**PROJECT MINUTES**

Project:	New W. Edward Balmer Elementary School	Project No.:	17020
Prepared by:	Joel Seeley	Meeting Date:	4/2/19
Re:	School Building Committee Meeting	Meeting No:	41
Location:	High School Media Center	Time:	6:30pm
Distribution:	School Building Committee Members, Attendees (MF)

RESPONSE TO COMMENTS  
MARCH 28, 2019

# VE LIST: A01- ITEM 16

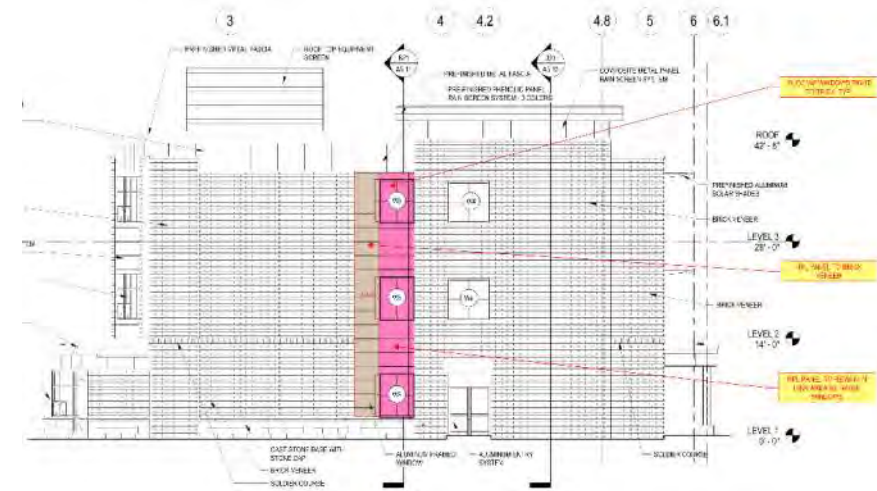
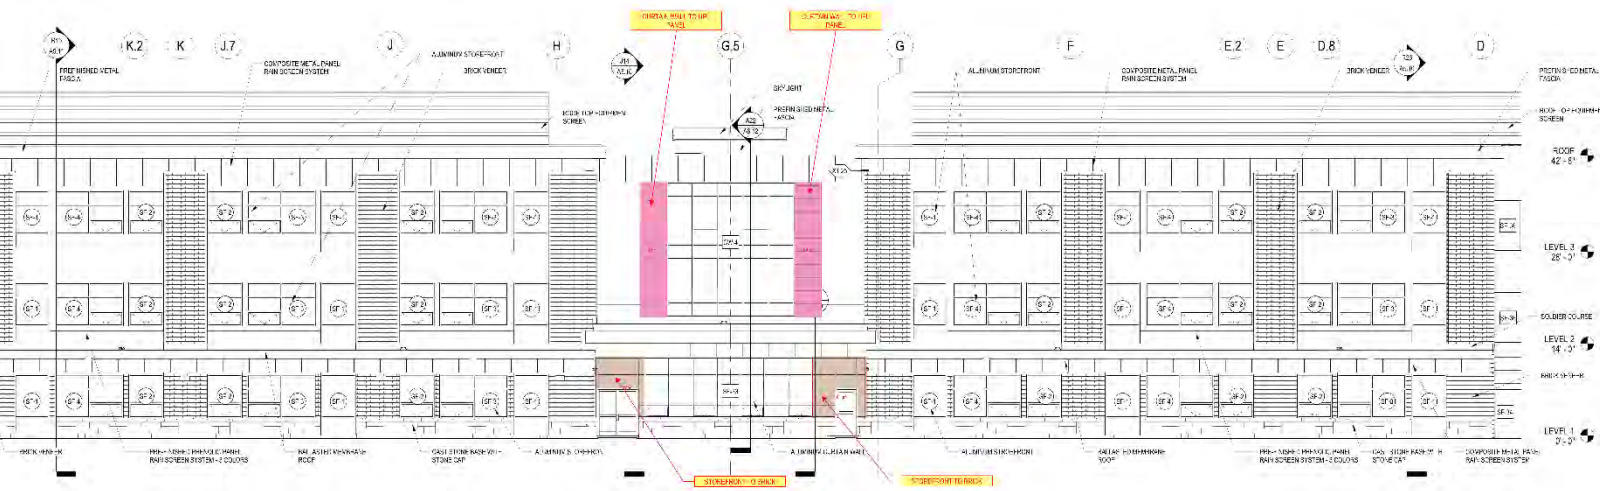
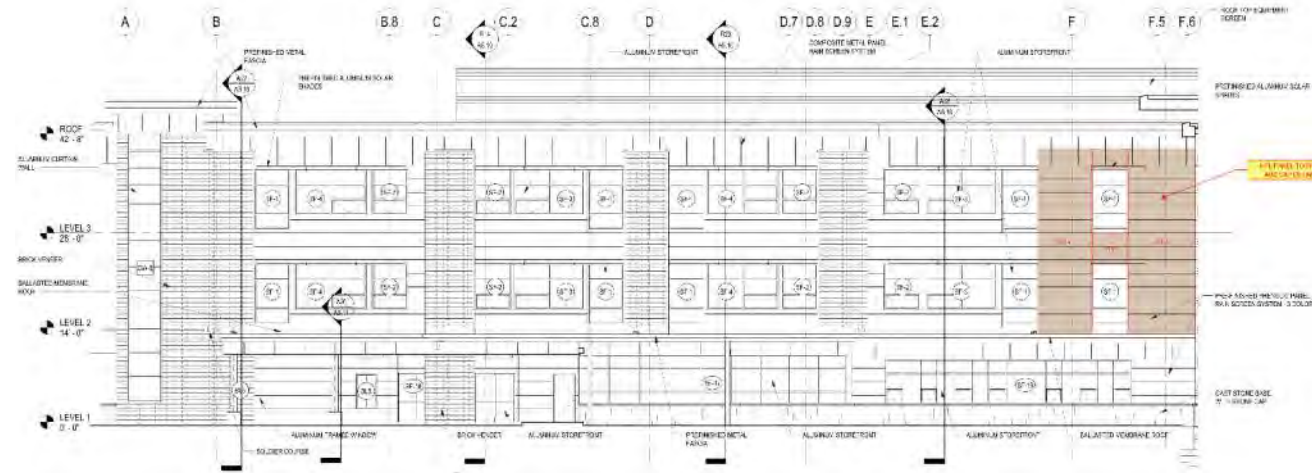
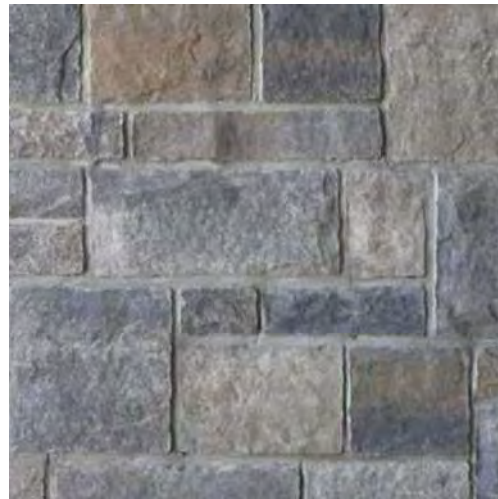
A01	A4 dwgs / Item 16	Provide Utility brick ILO standard Modular brick on entire building.	(\$90,585)
-----	----------------------	--	------------

# ADMIRAL SERIES

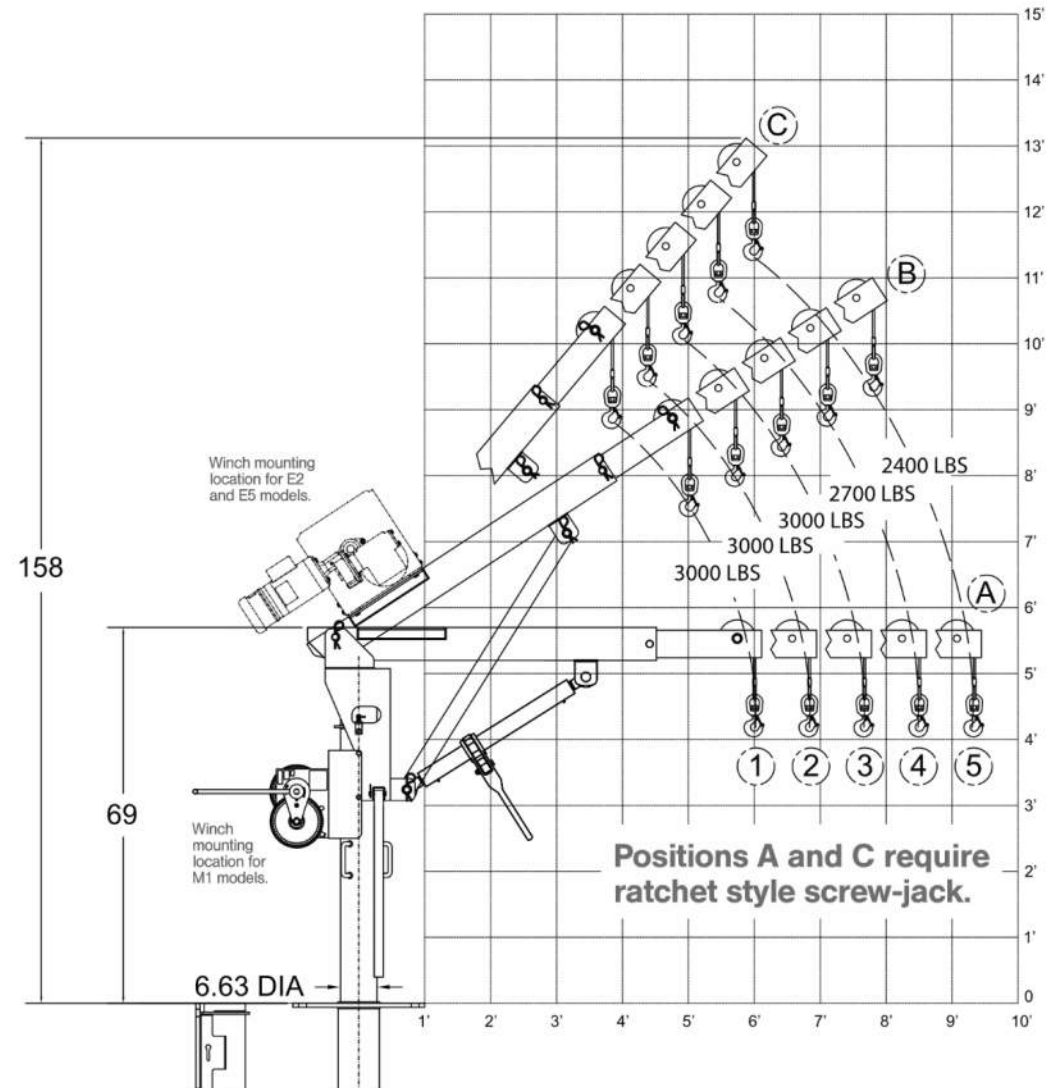
18.	Jeff Lundquist		We should consider having a hoist on the roof, so we don't need to bring in a crane/boom truck to hoist any materials needed for maintaining our equipment.	While this is a forward-thinking comment, the potential cost should be weighed against frequency of use, rental cost of a lift, and the provision of a small portable hoist (davit) for the roof hatch for small loads. See also Note 30. below. To be discussed with the Working Group - primarily Richard Maglione				PRICE FOR 4/2/19

ADD Roof Hoist

# VE LIST: ITEM 28

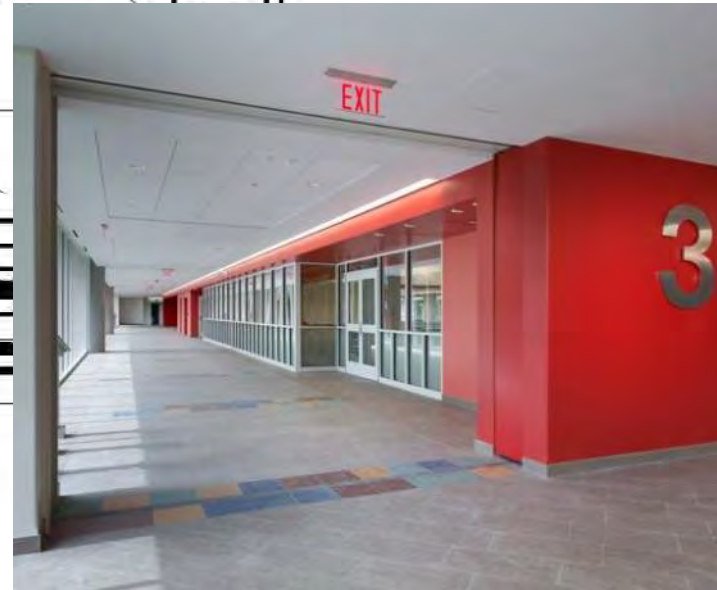
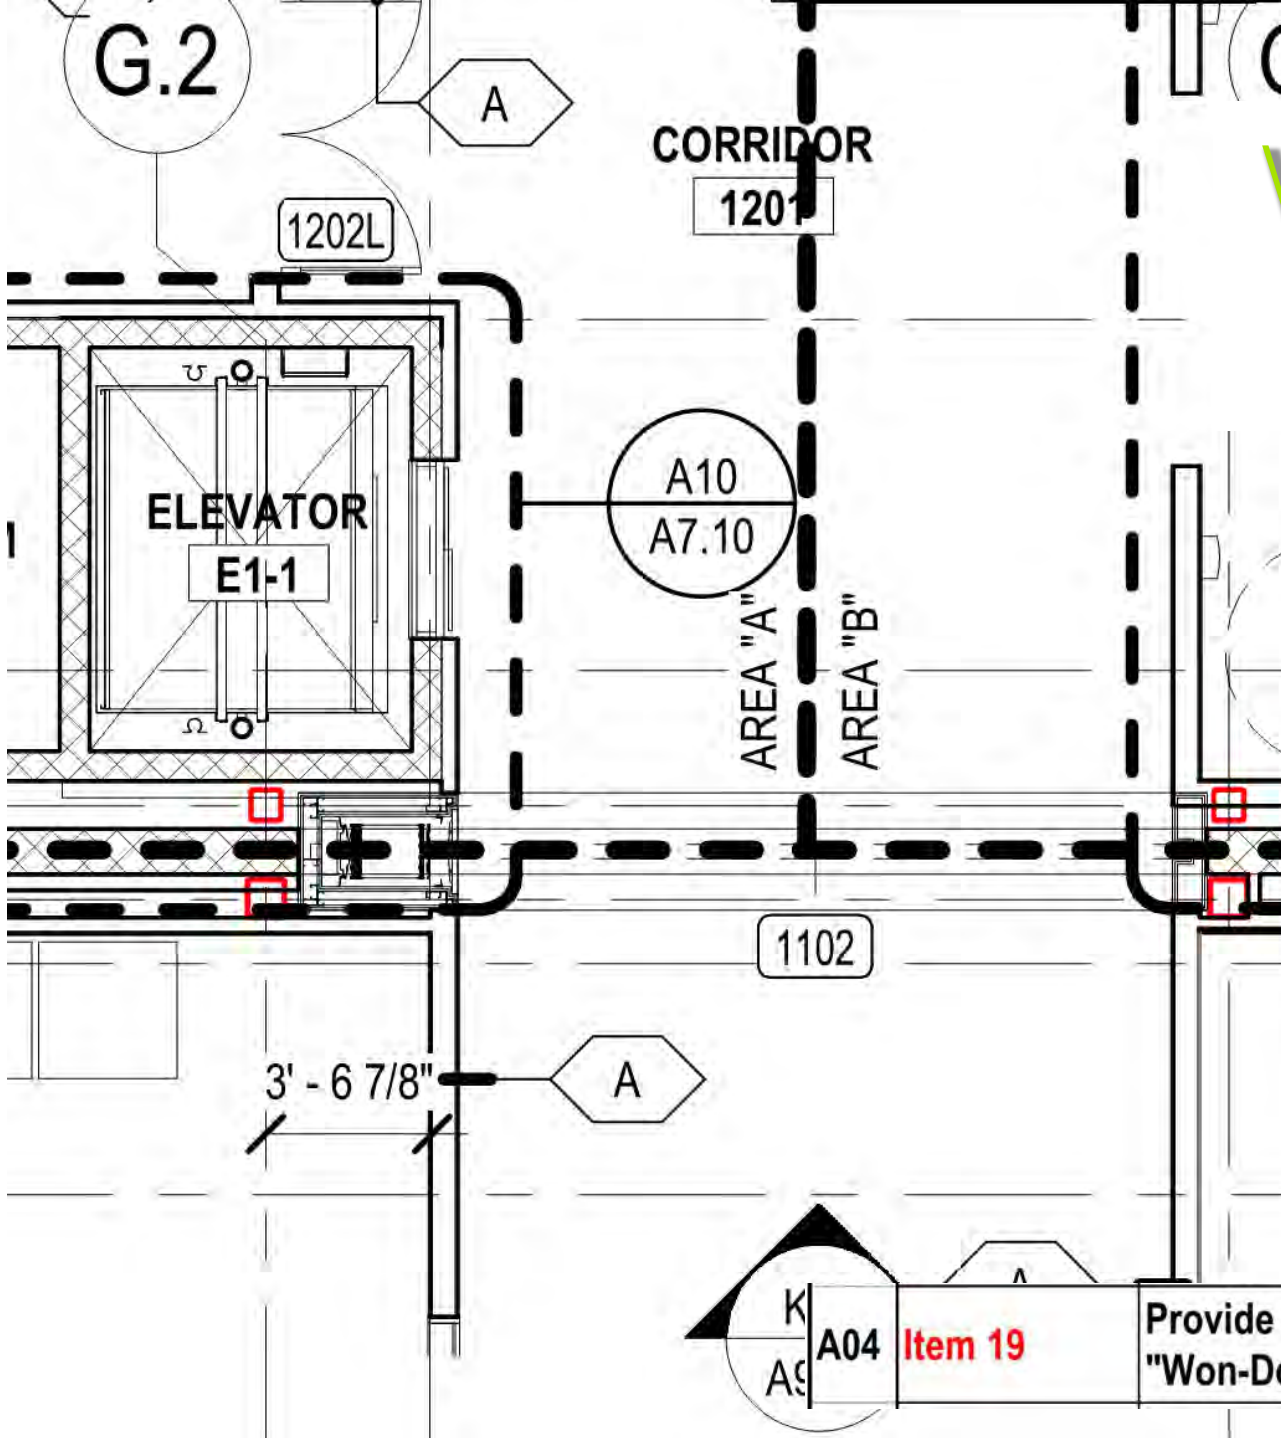
Delete specified exterior mock-ups and go with in-place ILO

(\$41,000)

# VE LIST: A04- ITEM 19

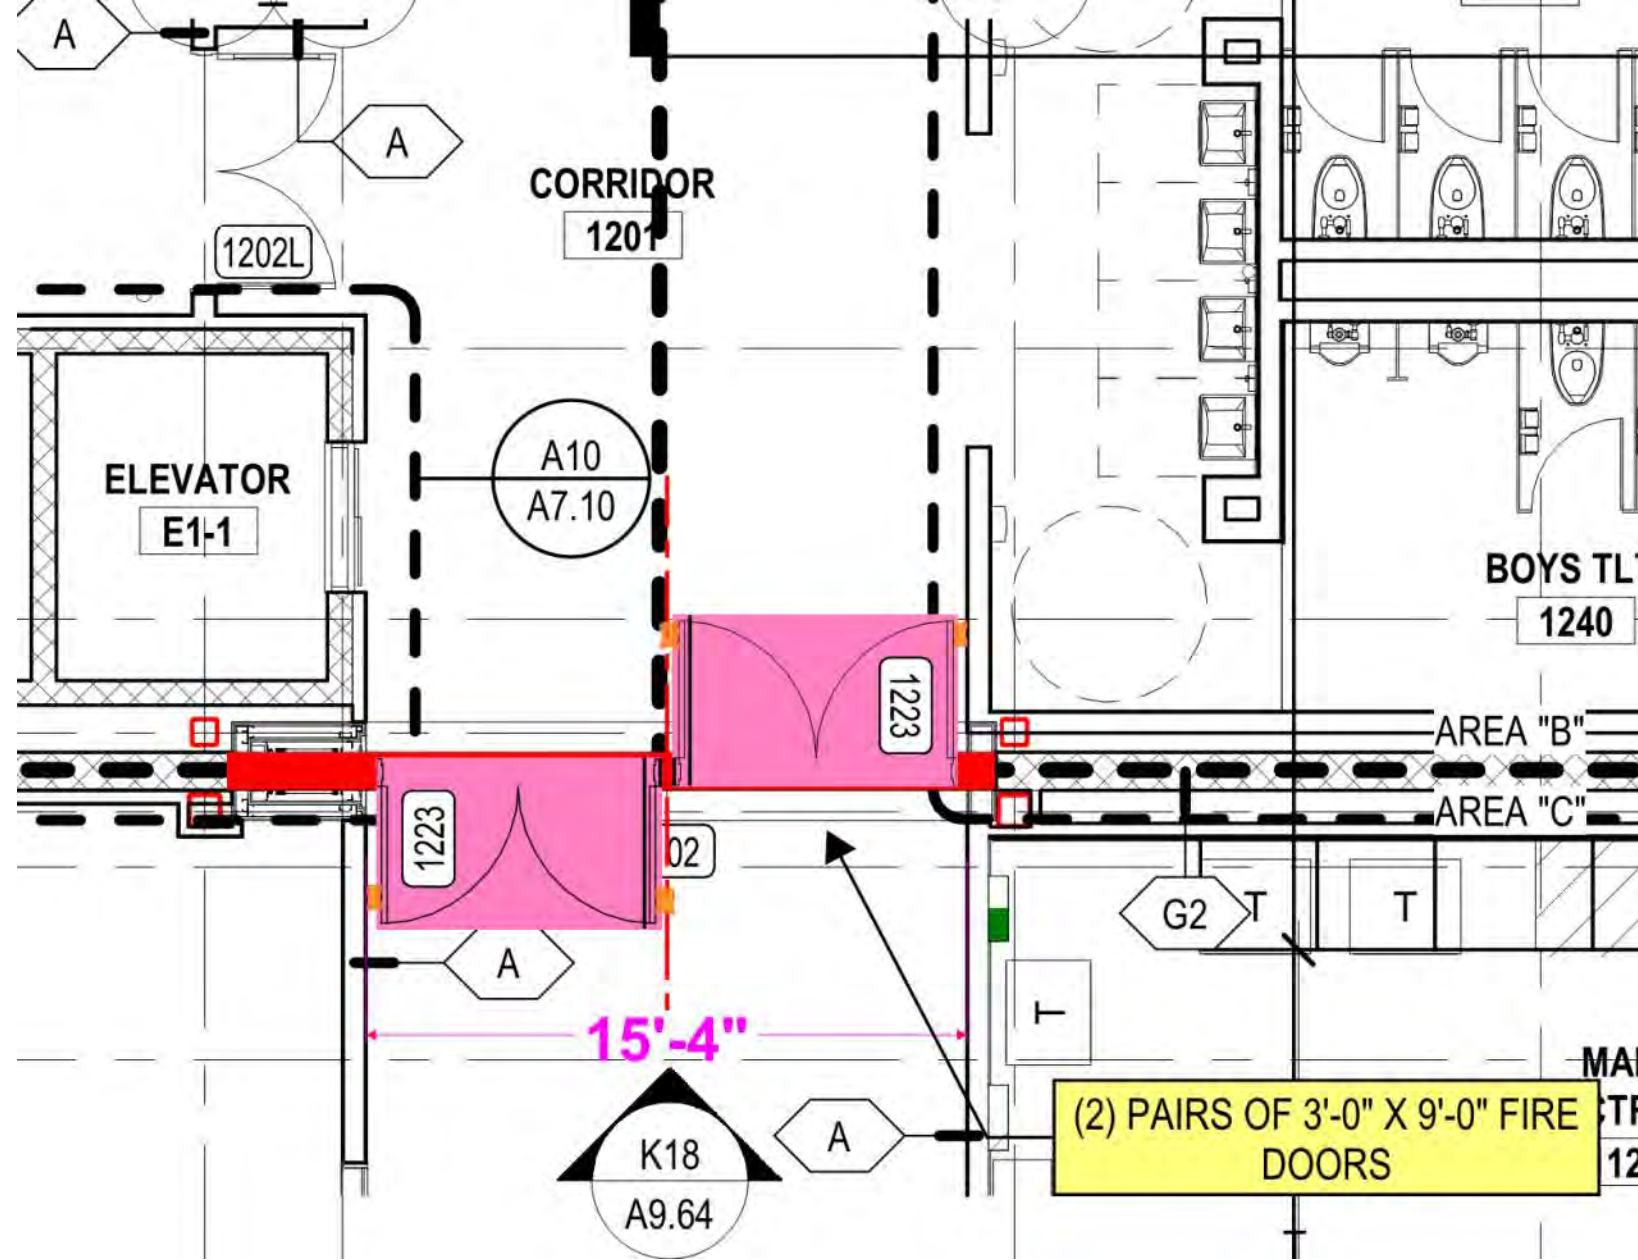
A04	Item 19	Provide swinging full-height fire doors [(2) pairs @ 4' w x 9' tall] ILO "Won-Door" sliding fire door (3 levels)	(\$66,932)
-----	---------	--	------------
